April 16, 2019

W.O. S7569

SUBJECT: Final Response to County of Santa Barbara Coastal Engineering Review,  
711 San Point Road, Carpinteria, CA, Cosmoledo Trust New Residence.

PROJECT  
INFORMATION,  
PROPOSED  
SITE PLAN,  
VICINITY MAP

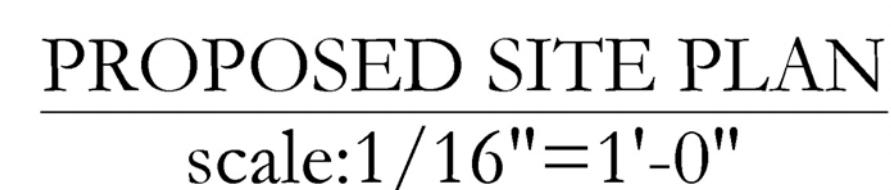
*2. The consultant states that there is an existing sea wall and revetment present seaward of the residence, however, no seawall is referenced on the plans. Please clarify if there is sea wall present, and if so, the location, dimensions and permit status of the sea wall.*

There is a double crested revetment fronting the site. The site topographic map (attached as APPENDIX I) shows the revetment(s).
